PLANNER'S REPORT

RE: Design Review - 831 Custer Street

The City of Hapeville has received a Design Review application from Michael Miles to remodel the exterior of an existing 1,800 square foot, two-story single-family dwelling at 831 Custer Street. The proposed changes include replacement fiber-cement siding, additional windows, the removal of a rear porch, and the conversion of an enclosed second-story side room to a screened-in porch.

AI.1

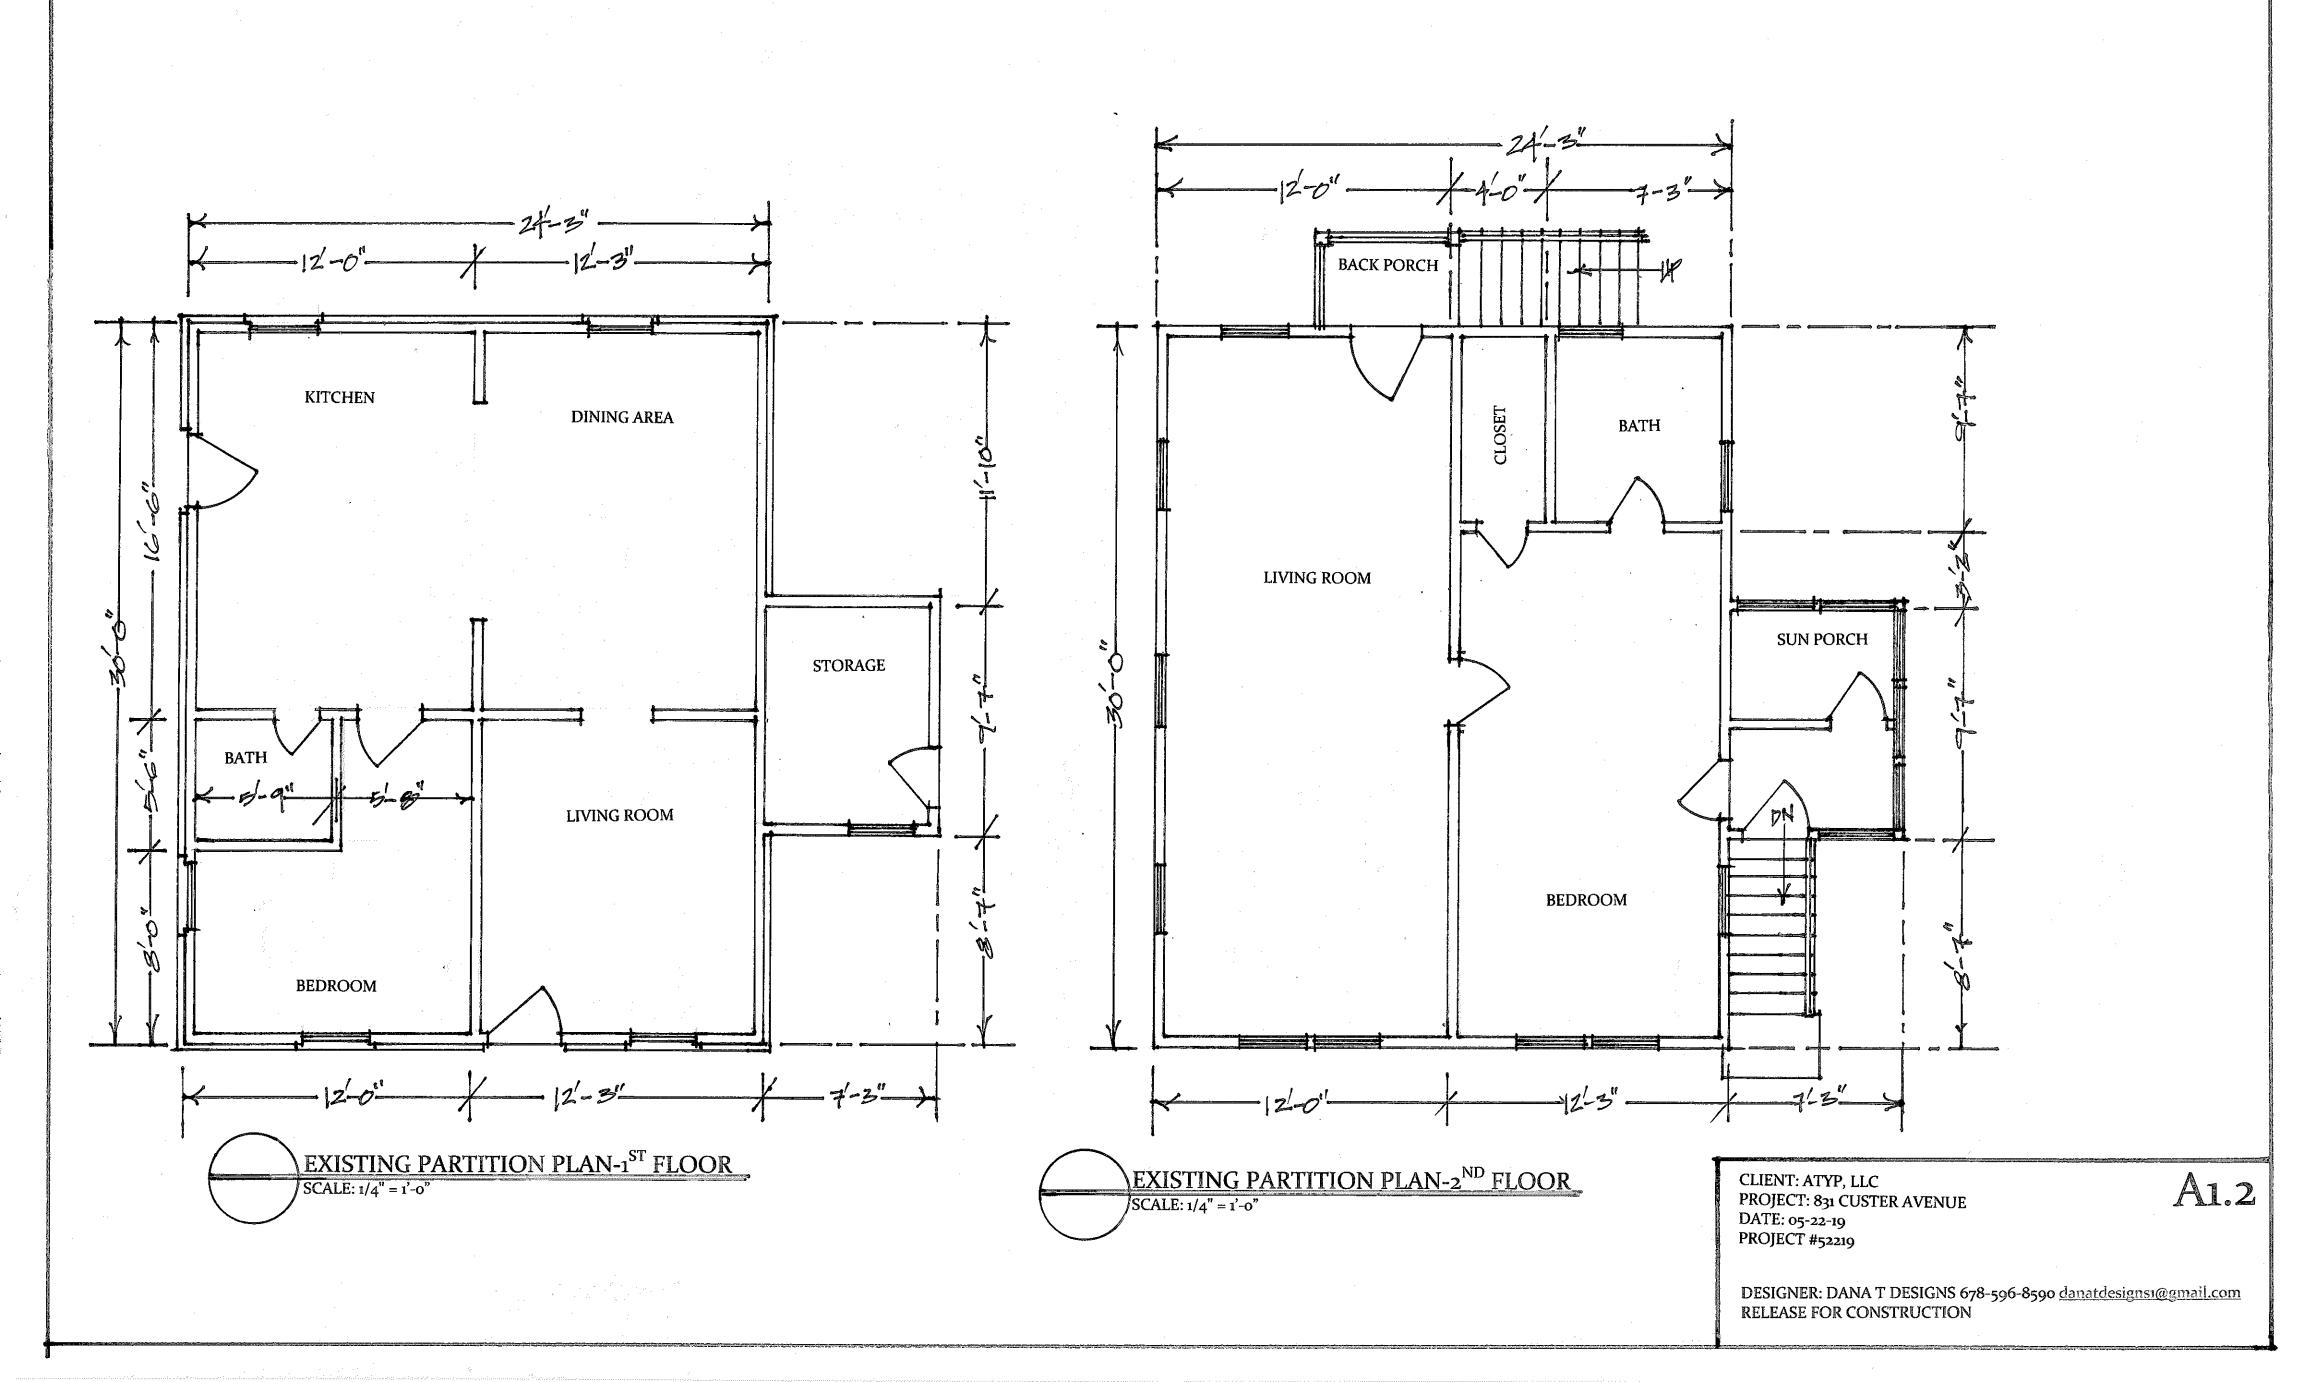
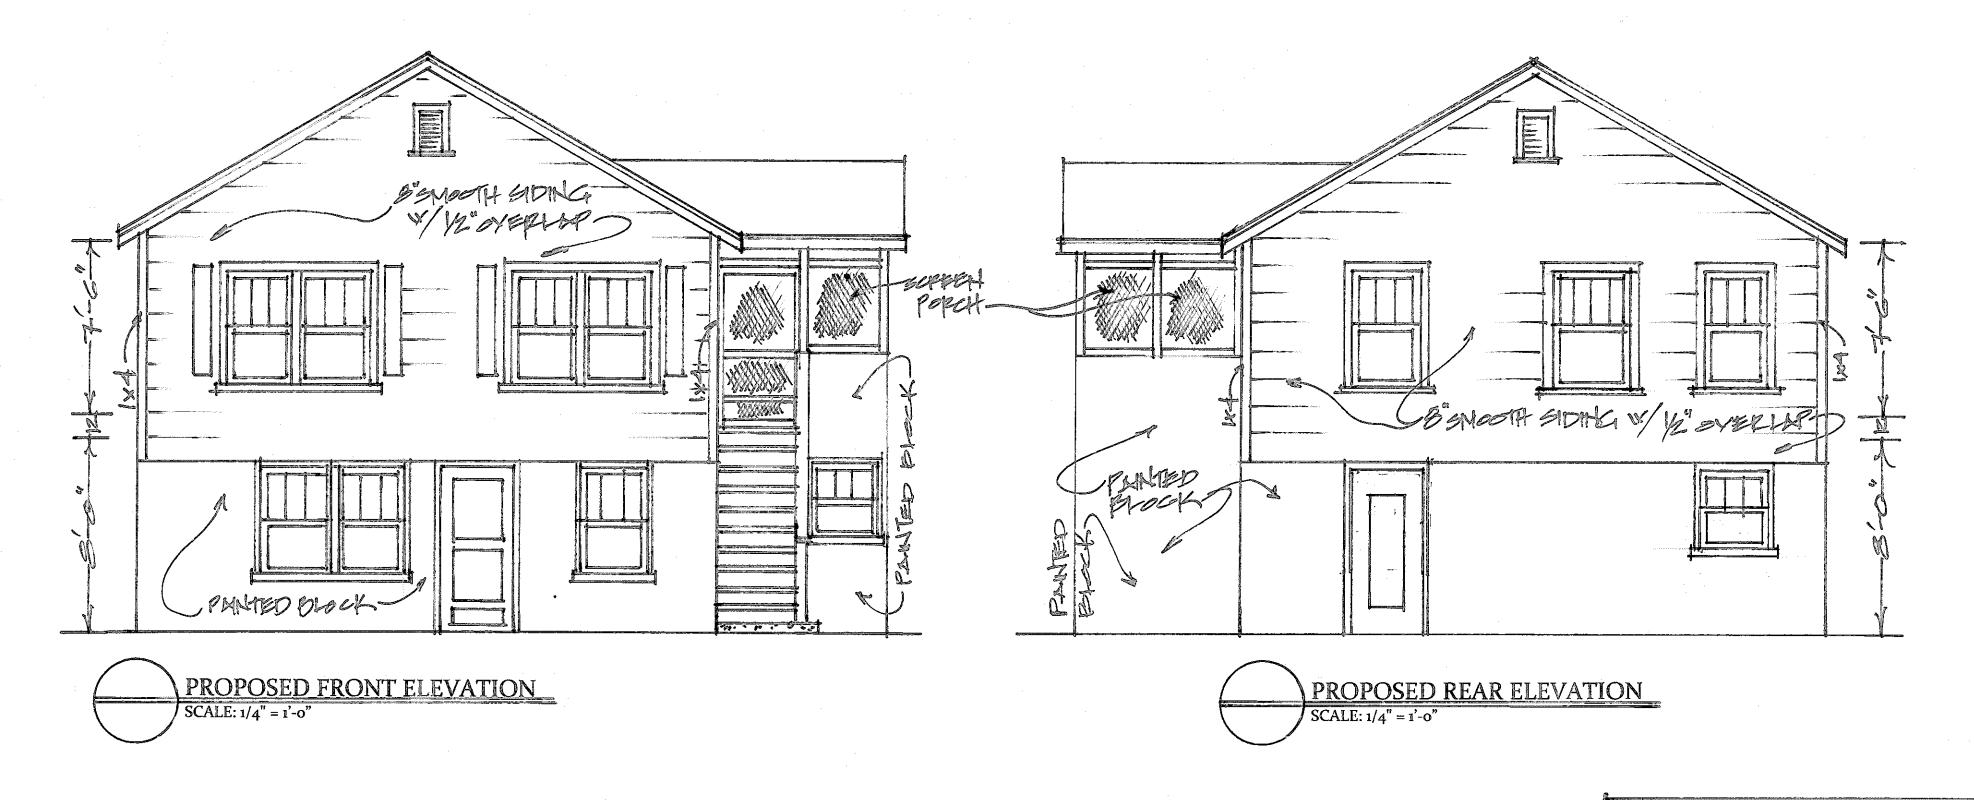
The proposed plans replace existing asbestos siding with cement-based siding on the second story but retain existing painted concrete block on the first story. Concrete blocks are not a permitted façade material.

PROPOSED LEFT SIDE ELEVATION

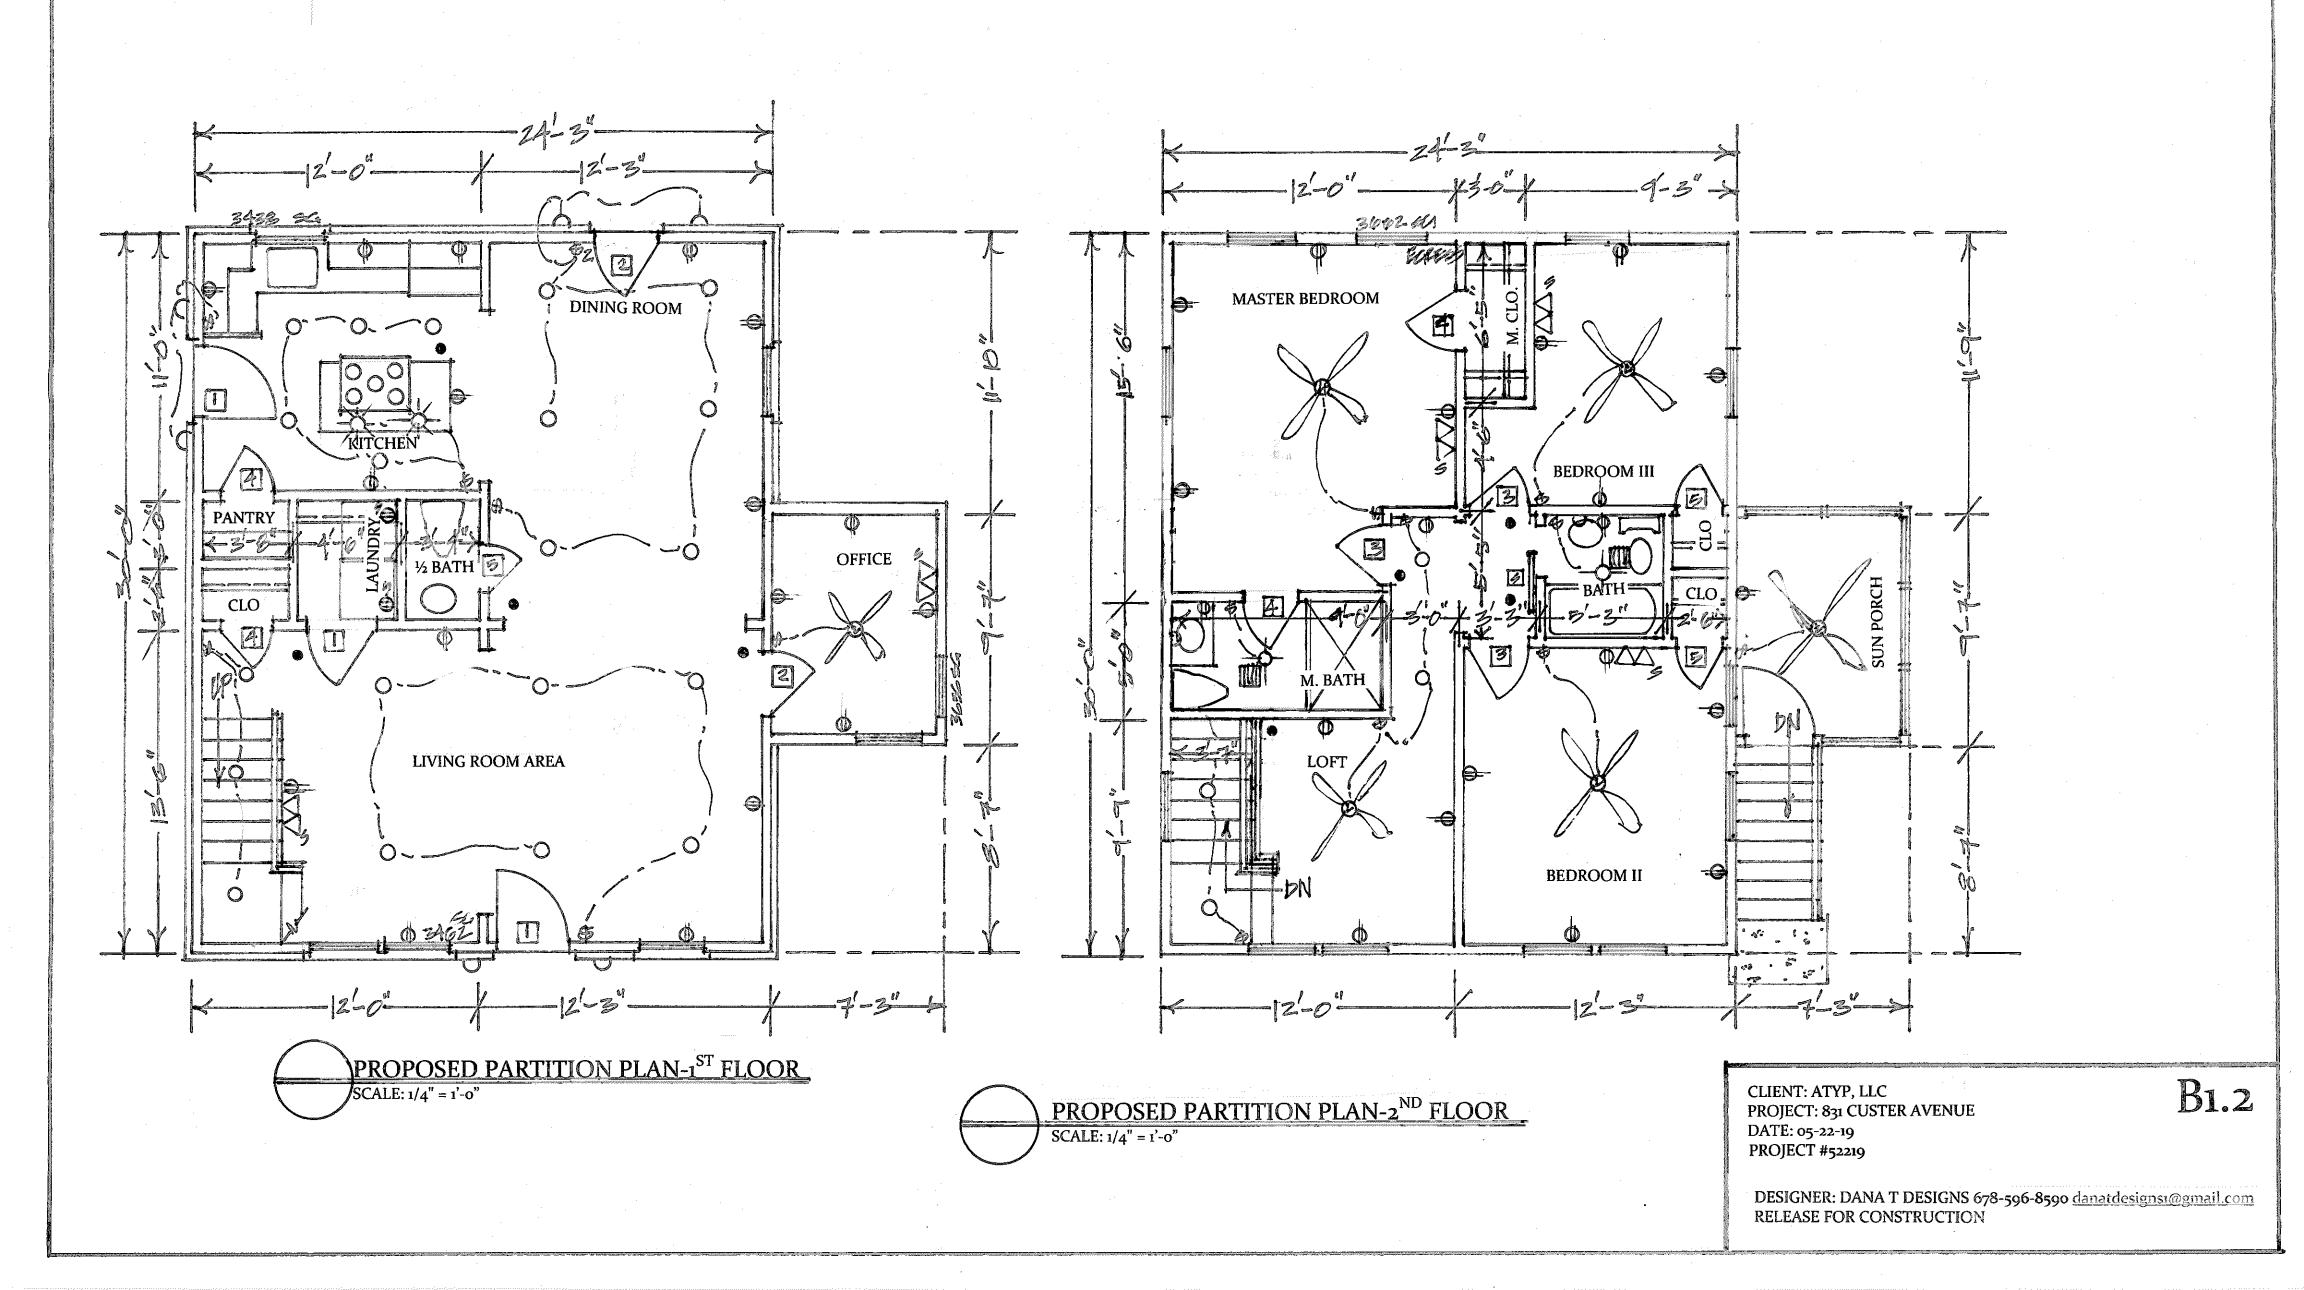
Porches may not be enclosed with screens or other materials that hinder visibility. The proposed porch is screened, which is not compliant.

Stoops and porches shall be a maximum of four feet from grade to the top of the stairs. A second story porch is not compliant. Porches must have a clear depth of at least 8'. The proposed porch has a clear depth of approximately 7', which is not compliant.
